I-285@ CR 4519/Atlanta Road

GDOT Project Number: STP00-0222-01(001), P.I. No. 752300

Value Engineering Study Report

June 2009

COUNTY
COBB

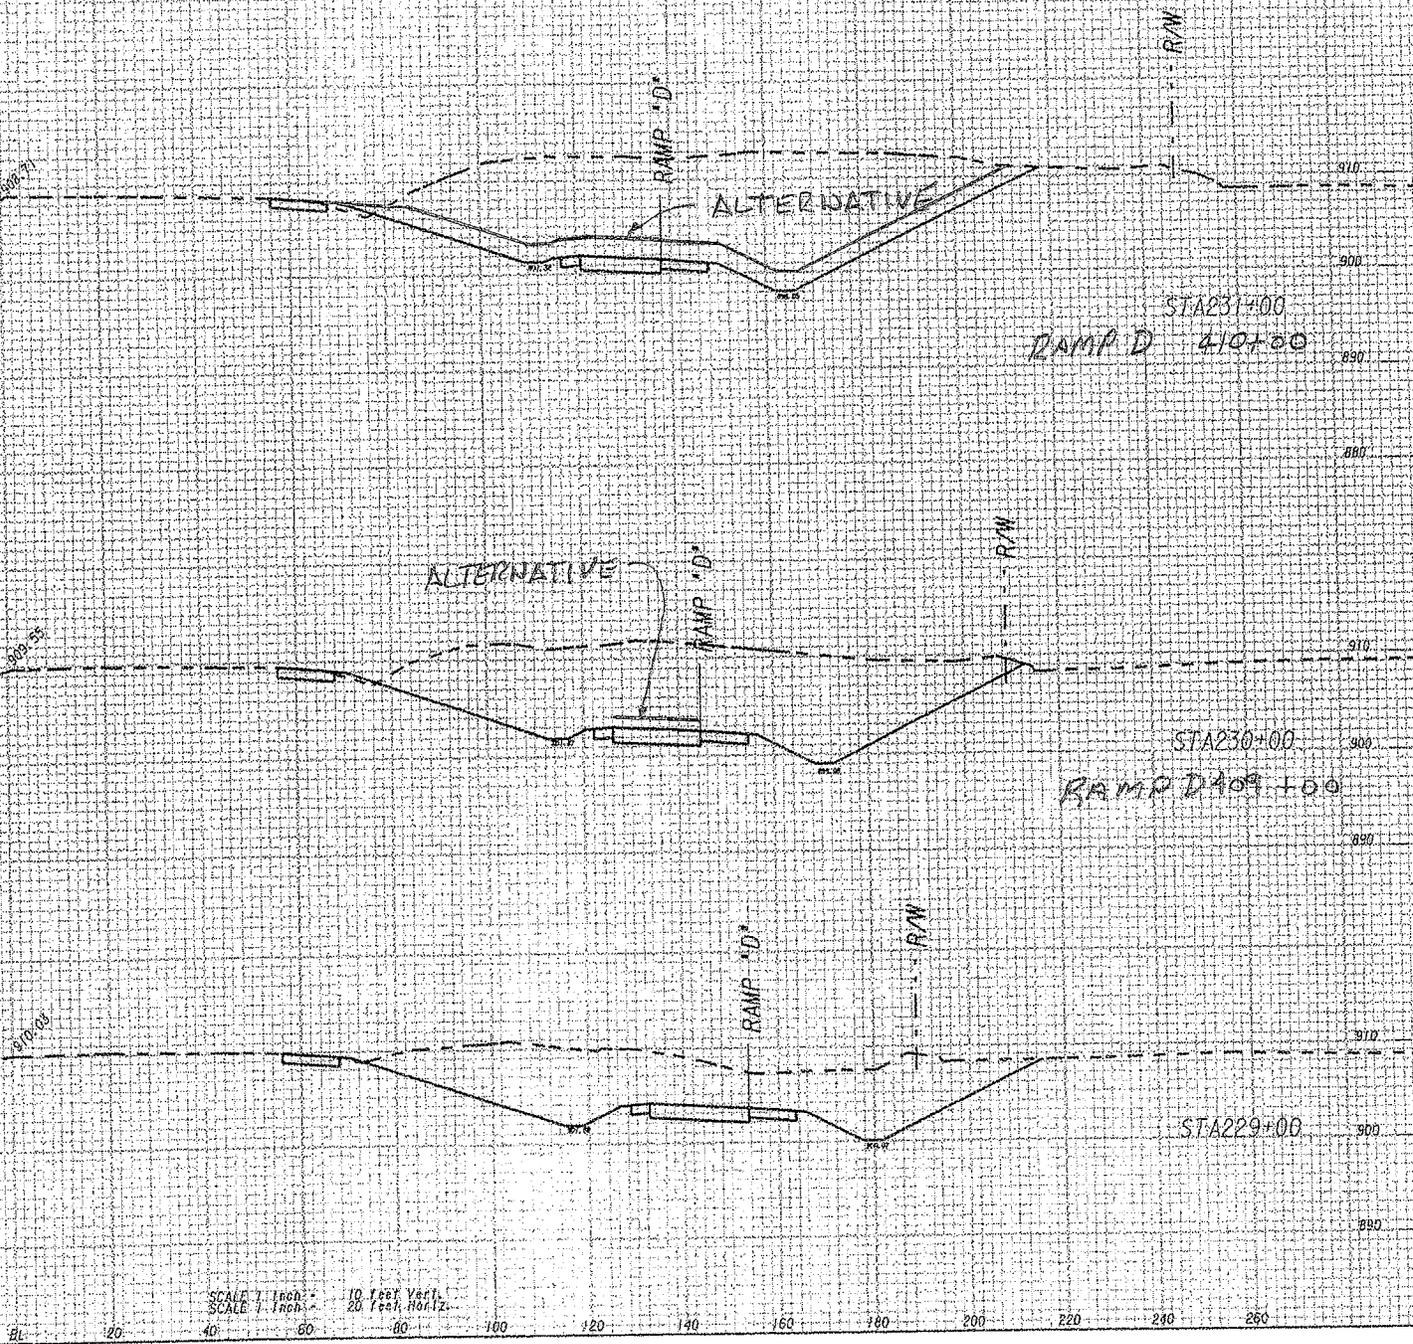
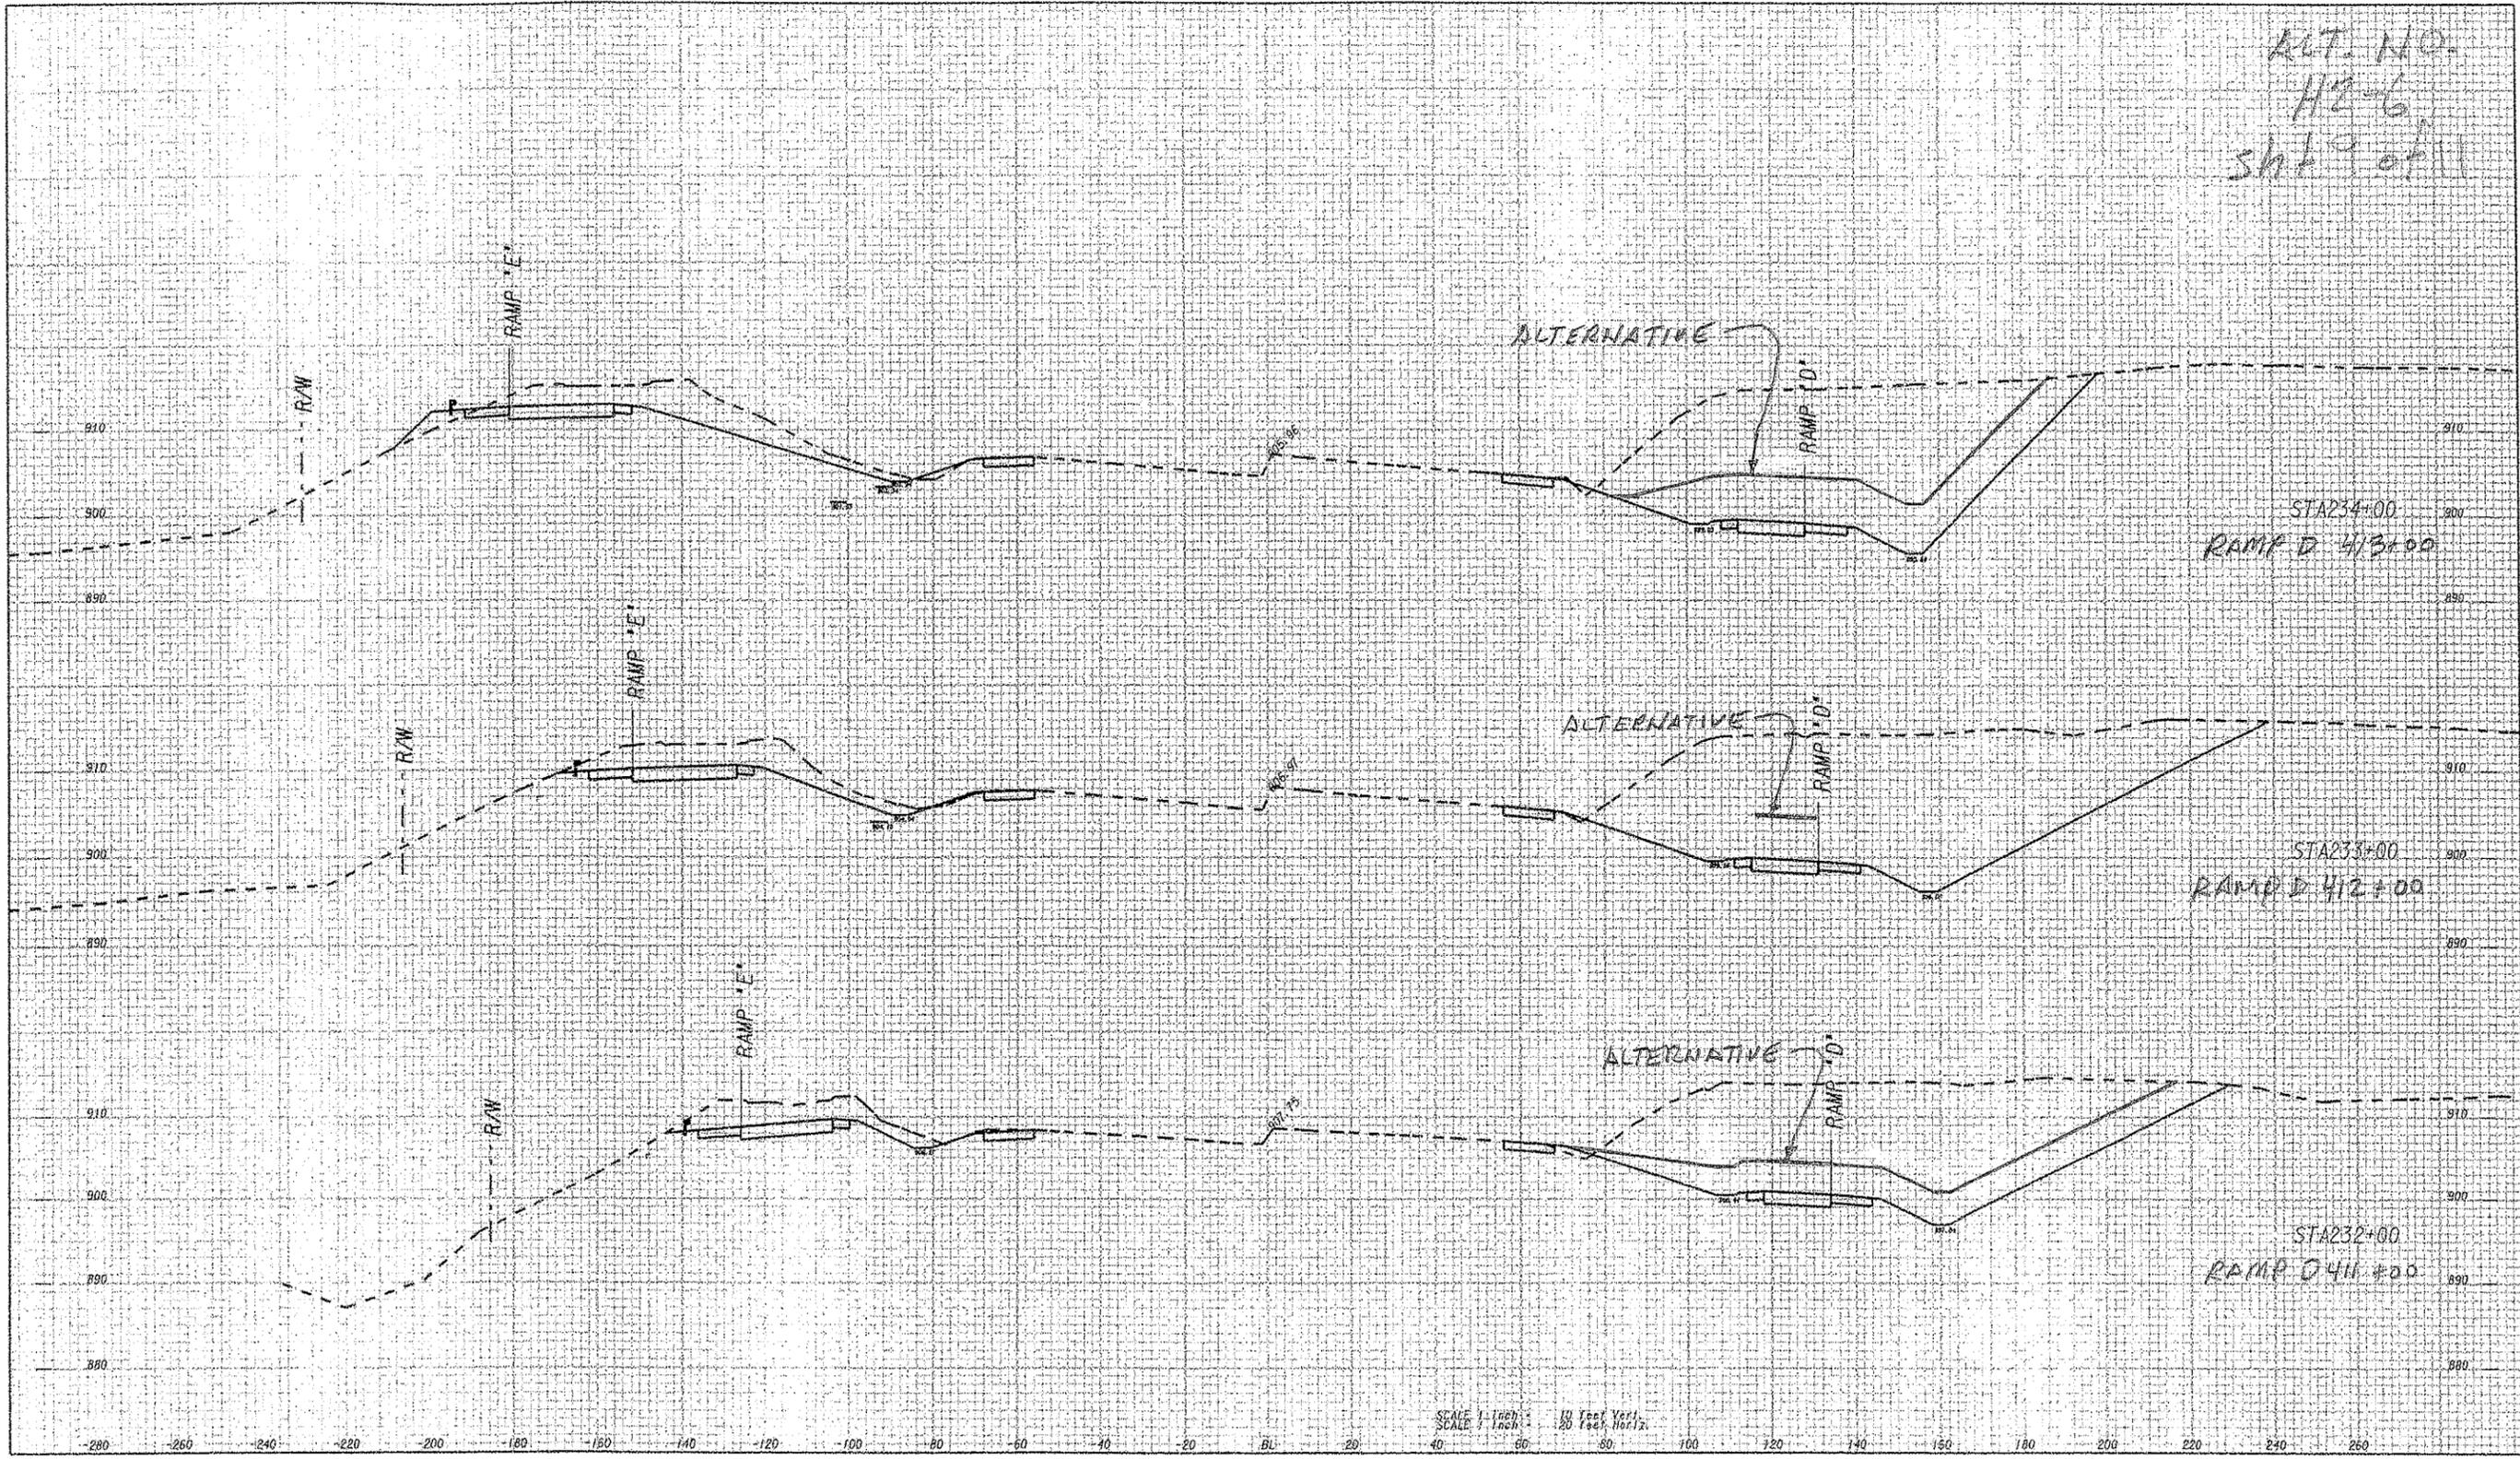
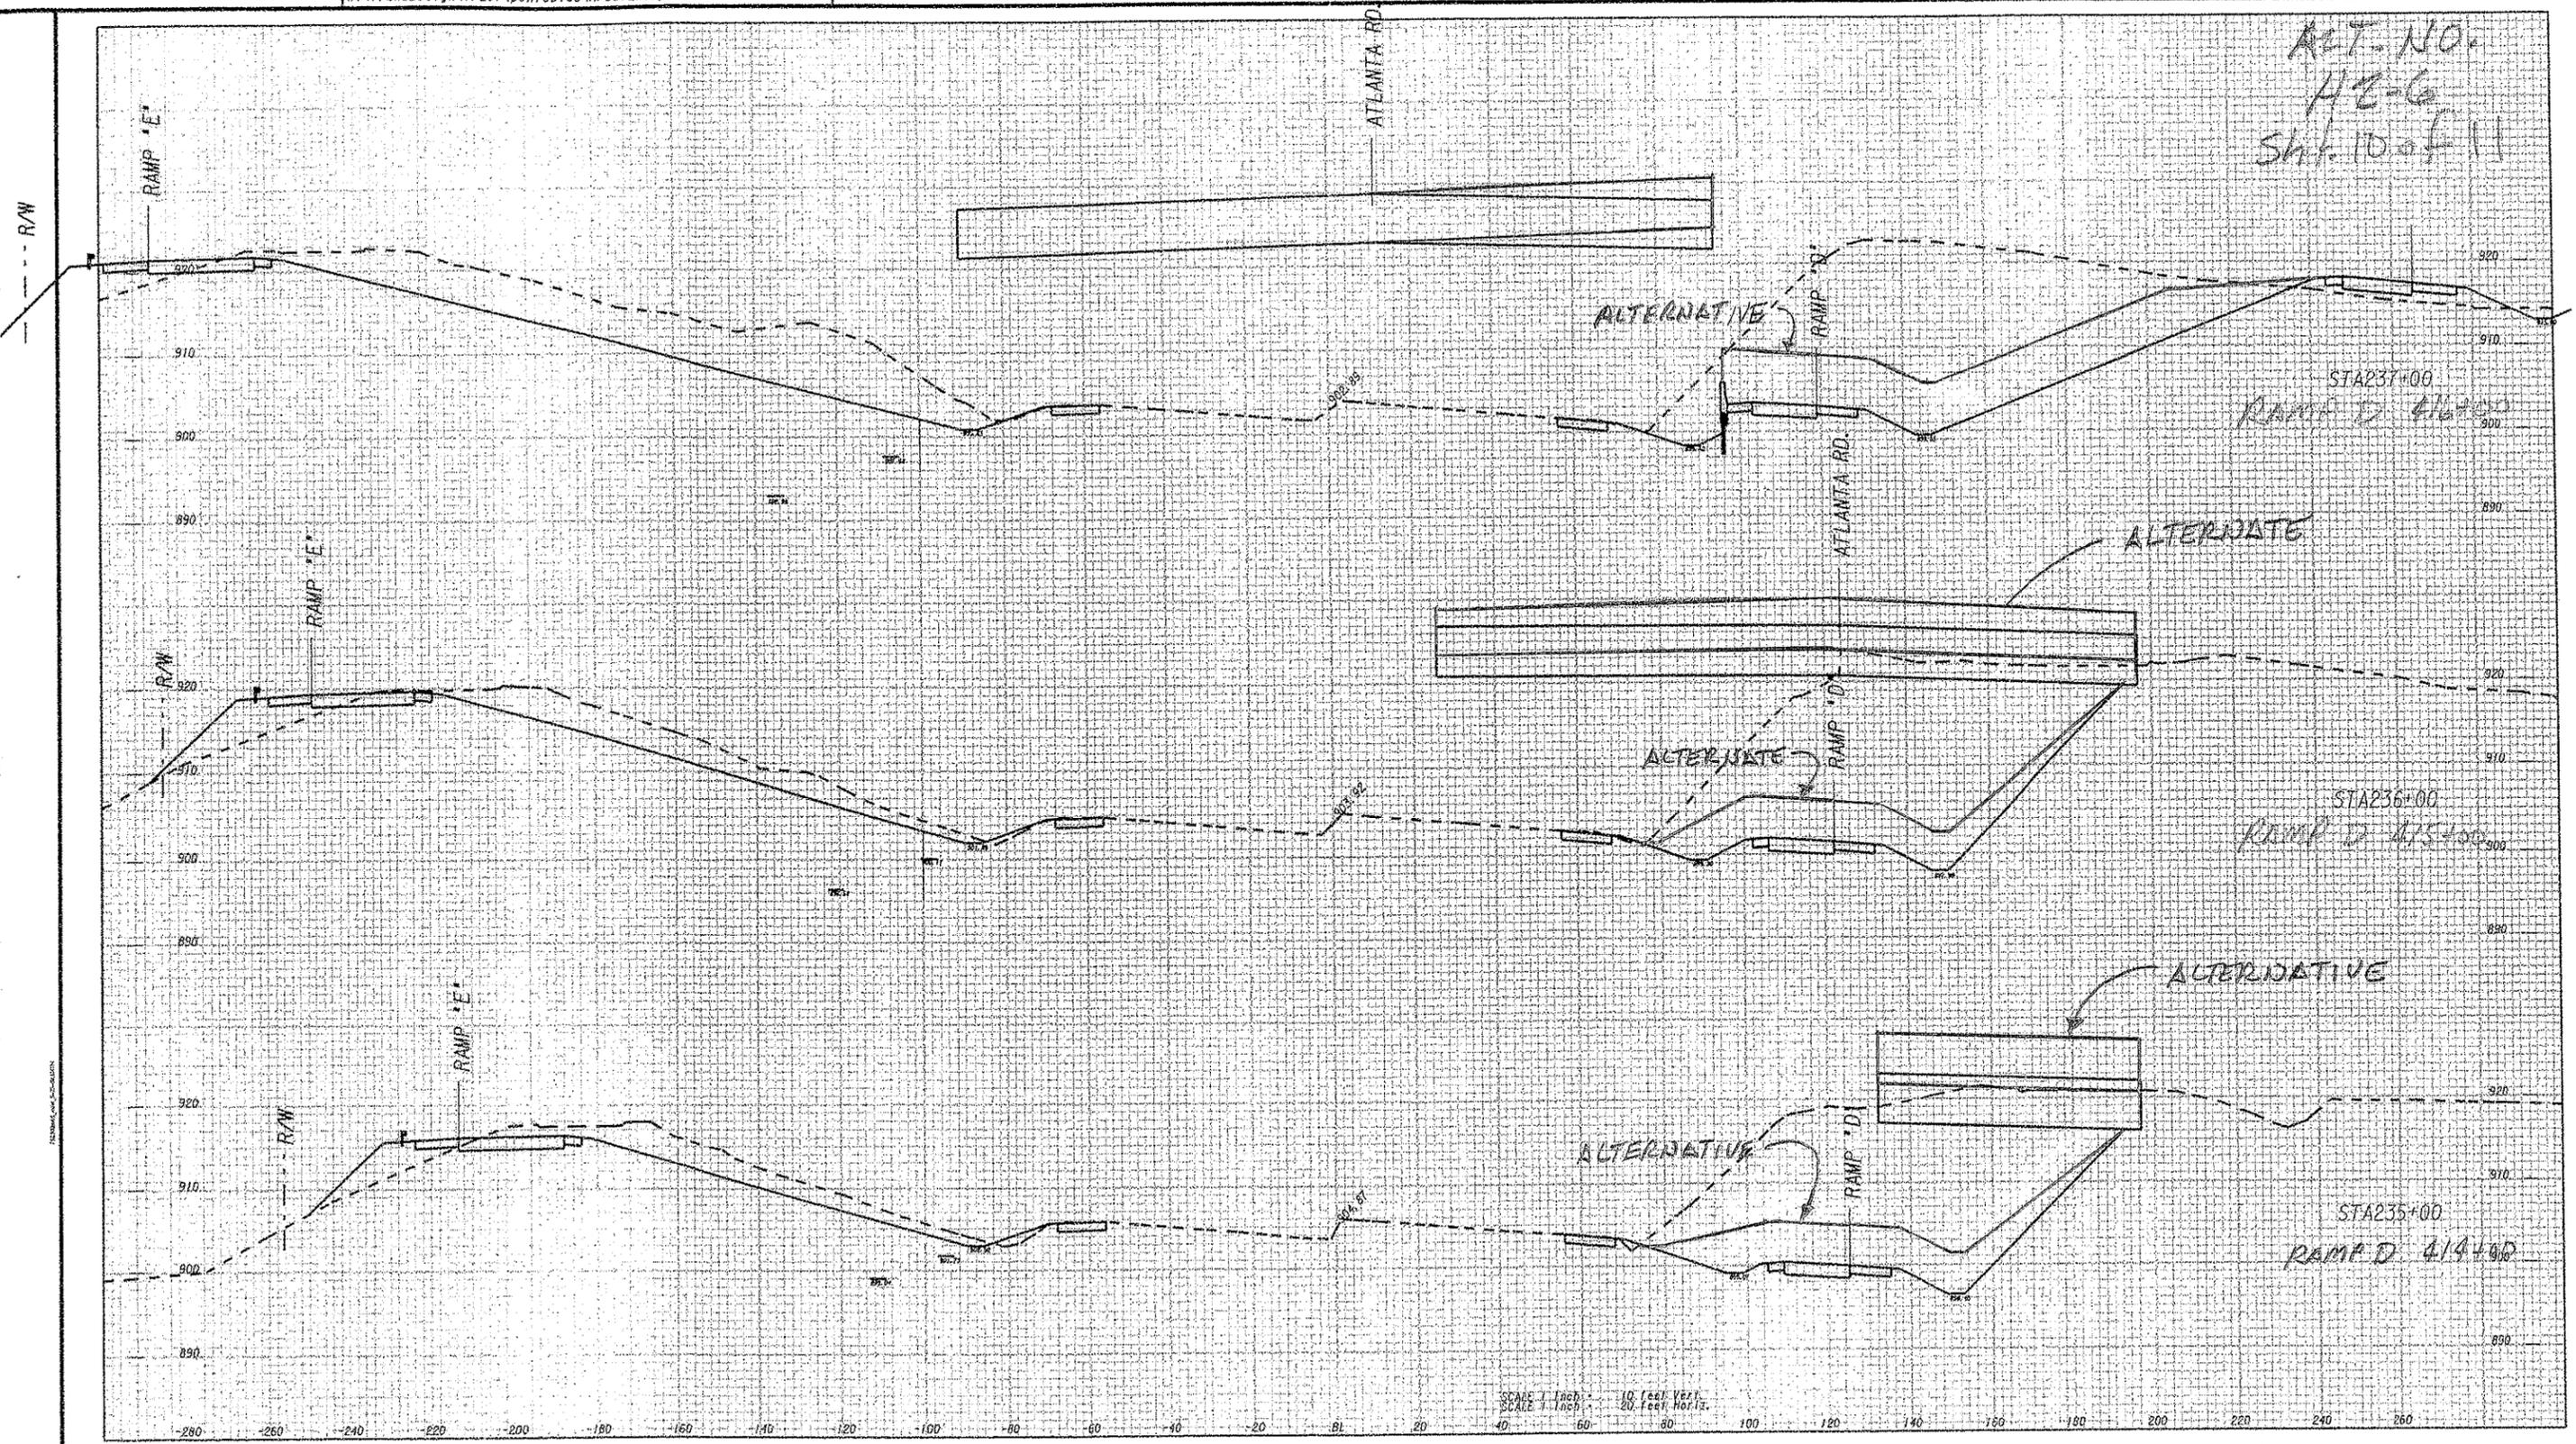
Raise the Atlanta Road Bridge profile on the east side sufficiently so that the new northbound I-285 CD lanes will be above the existing pipeline. Build the new CD lanes with a bifurcated median barrier so that the west side of the new lanes is higher than the east side of the existing lanes and high enough to provide adequate cover over the existing Colonial Pipeline. Raise the profiles of Ramps B and D to match the profile of Atlanta Road and the profile of Ramp D to also provide sufficient cover over the Colonial Pipeline.

This alternative will necessitate staging the Atlanta Road construction and making accommodations for raising the road east of the bridge. Included in this is the addition of sheet piling between the existing eastbound and westbound lanes of Atlanta Road. It is believed that the amount of extra fill material for Ramp B will be offset by the reduction in cut material for Ramp D.
